Decision No. [2022] NZEnvC 37

CONSENT ORDER

Memorandum for Consent Orders – ENV-CHC-2021-83 Annexure A (Tracked changes version) -

Resource consent number RM190790

3.9 CARE FACILITY UNIT - SECTION ELEVATION E-E

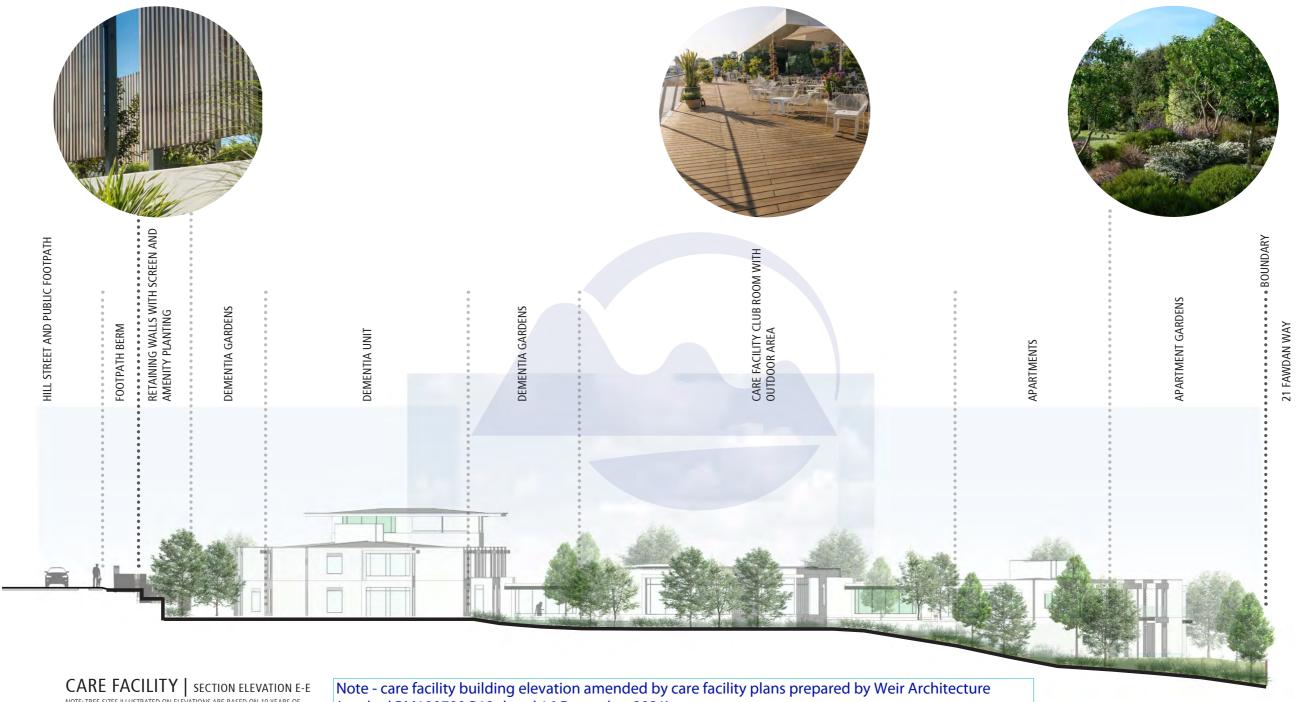
Note - care facility building elevation amended by care facility plans prepared by Weir Architecture (marked RM190790 B12 dated 16 December 2021)

added under consent order ENV-CHC-2021-83
